Dominion Nuclear Connecticut, Inc.
Millstone Power Station
Rope Ferry Road
Waterford, CT 06385

Cooling Water
Alternatives

MILLSTONE POWER STATION
 COOLING-WATER SYSTEM TECHNOLOGY STUDY
 RESPONSE TO ESSA TECHNOLOGIES LTD. REPORT DATED JANUARY
 21, 2003 AND CONNECTICUT DEPARTMENT OF ENVIRONMENTAL
 PROTECTION LETTER OF FEBRUARY 10, 2003

Figure 2: Parallel Offshore Barrier, Proposed DNC design
(colored by larvae concentration)

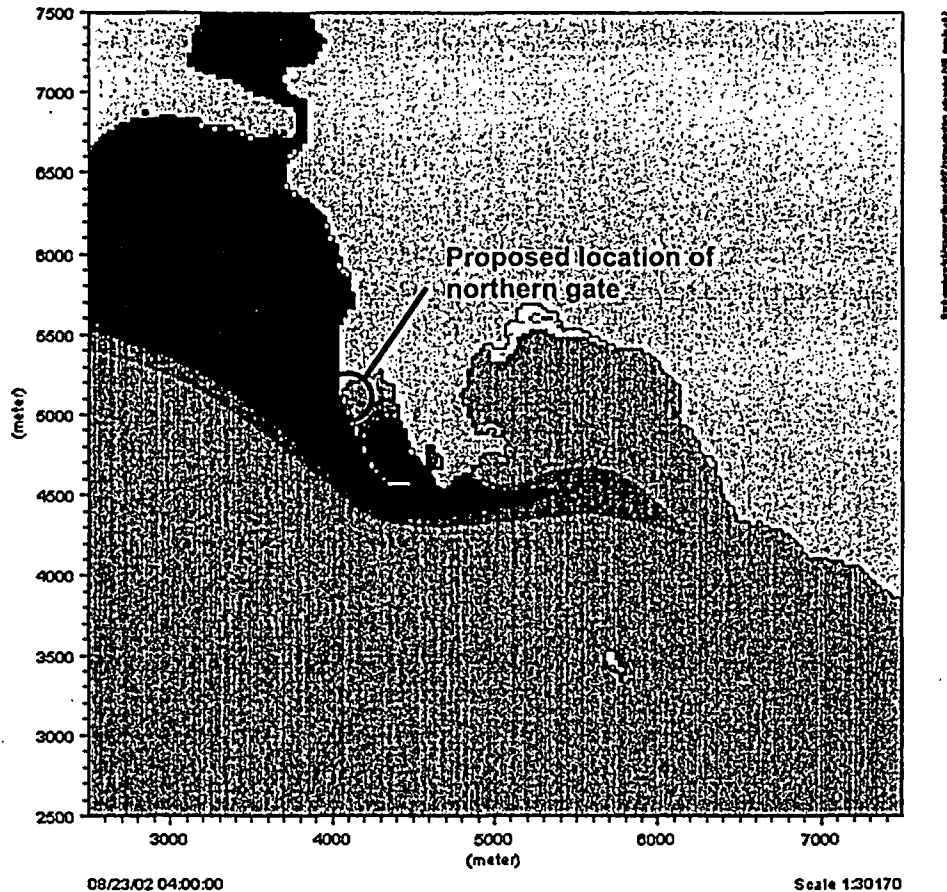
ESSA Comment: "A third possible strategy to mitigate recirculation of heated discharge with the shoreline barrier that could be simulated with the model is the effect of the discharge from the quarry being relocated to the Northeast side of the quarry into the bay that is opposite to the intakes. Discharging the heated effluent to the Northeast side of the quarry headland may be sufficiently far from the intakes to prevent recirculation of the discharge during a flood tide."

Response: This modification could be studied with the numerical model (at least in a rudimentary way). However, discharging water into the bay that is opposite the intakes would heat the water of the embayment substantially. With the current design, the discharge at the end of Millstone Point releases heated water into a relatively deep area in Niantic Bay where tidal flows are vigorous (Figure 1 – deep water areas at the end of Millstone Point) this helps to
